**Re: Supplemental Investigation Work Plan
Concourse Village West Apartments – North
180 East 156th Street
Bronx, New York
NYSDEC BCP Site No.: C203091**

Re: Supplemental Remedial Investigation Work Plan
Concourse Village West – North (C203091) at 180 East 156th St, Bronx

**Re: Supplemental Investigation Work Plan (SIWP)
Concourse Village West – North (C203091) at
180 East 156th Street, Bronx, NY**

<p>180 EAST 156TH STREET BRONX, NEW YORK</p>		<p>PROPOSED SOIL BORINGS AND MONITORING WELL LOCATION MAP</p>
<p>CONCOURSE VILLAGE WEST APARTMENTS - NORTH SUPPLEMENTAL INVESTIGATION</p>	<p>Project 1700655</p>	<p>APRIL 2018 Fig. 1</p>

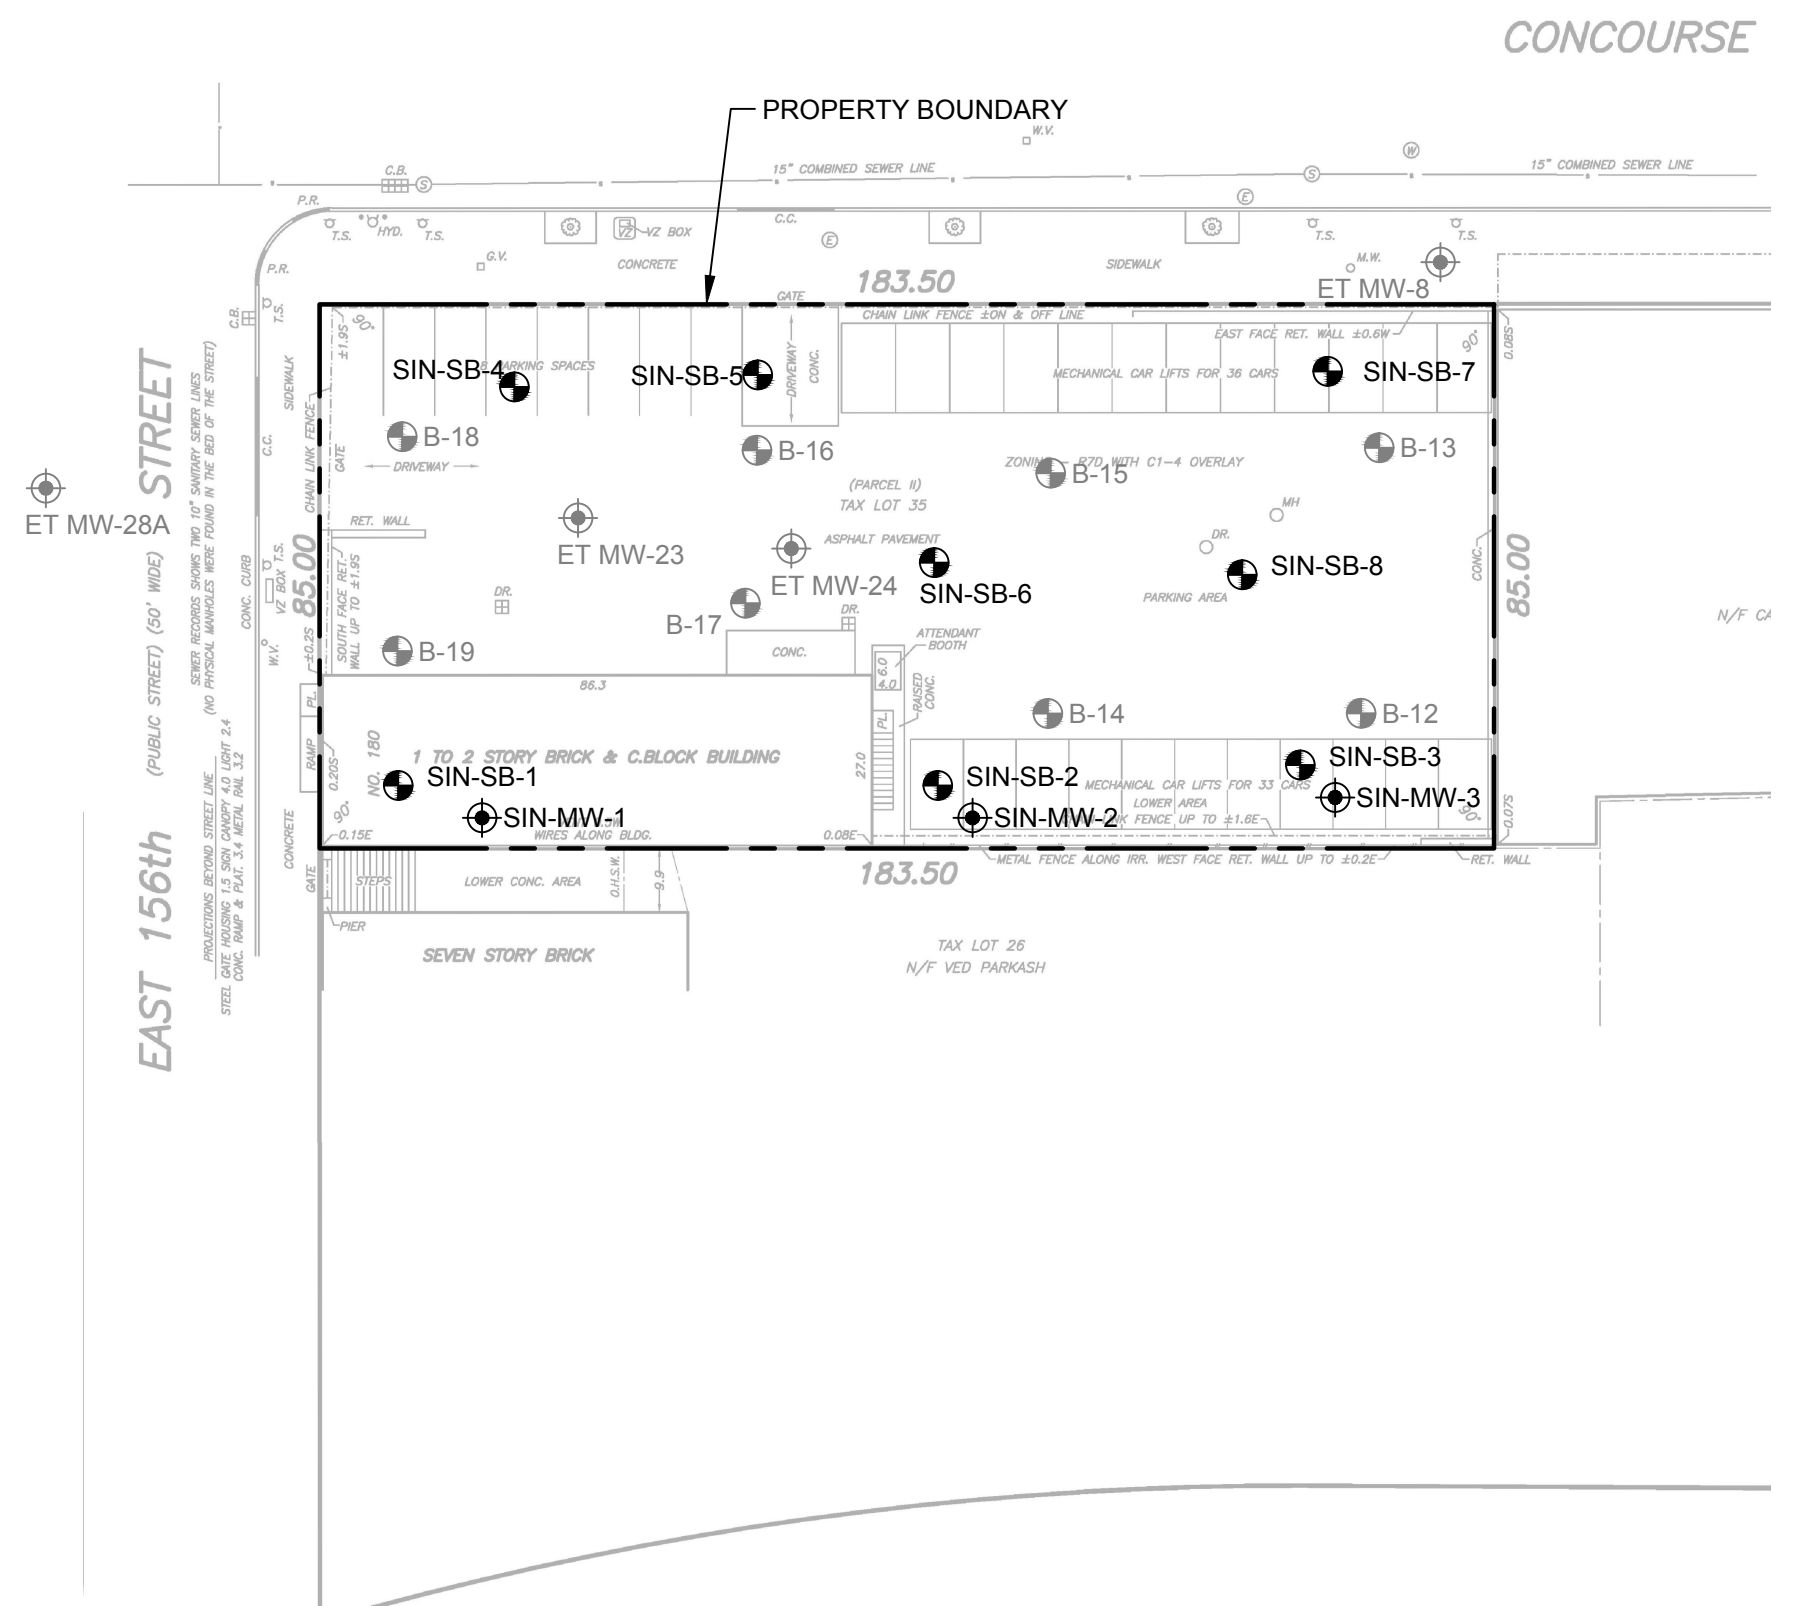
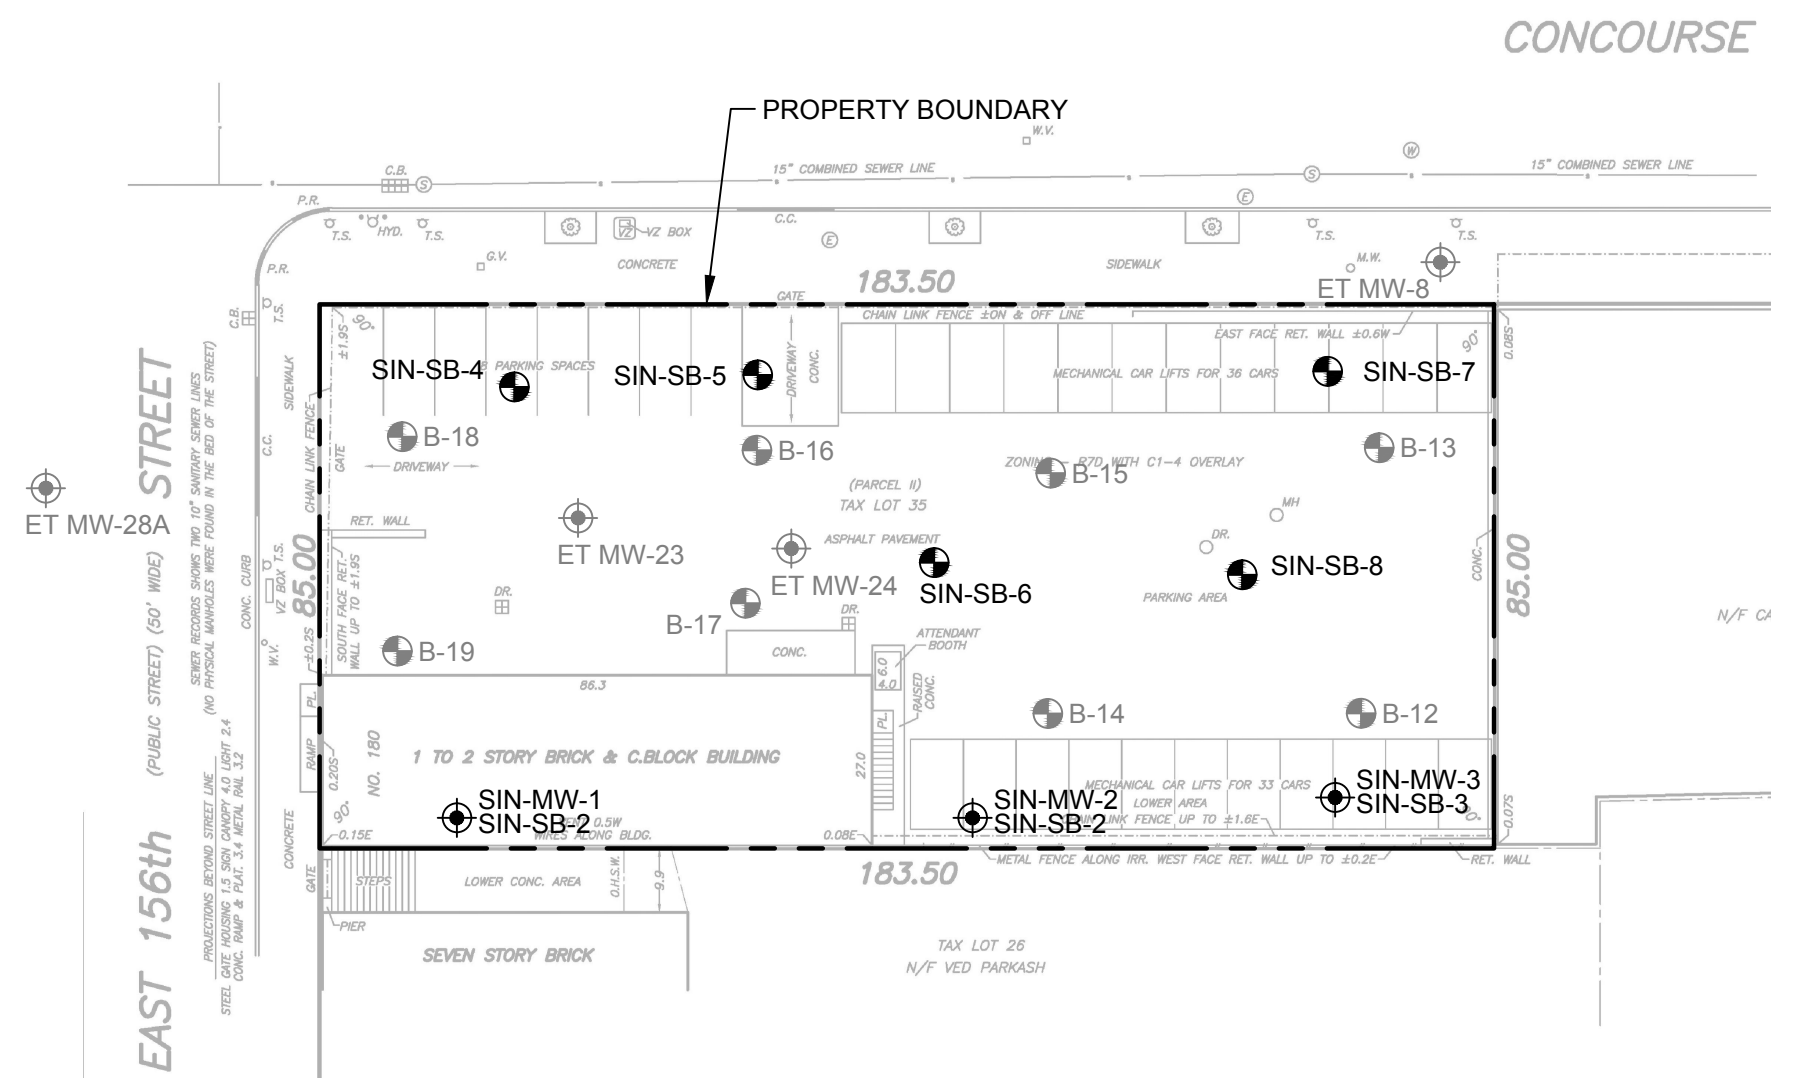
4. Co-locate wells and soil borings on Figure to reflect the wells being placed in the soil borings if that is the intent.
5. All sample results will need to be Category B deliverables, validated and a DUSR provided.

4. Co-locate wells and soil borings on Figure to reflect the wells being placed in the soil borings if that is the intent.

*Please see the attached, revised **Figure 1**. This Figure will supersede the figure submitted April 4, 2018.*
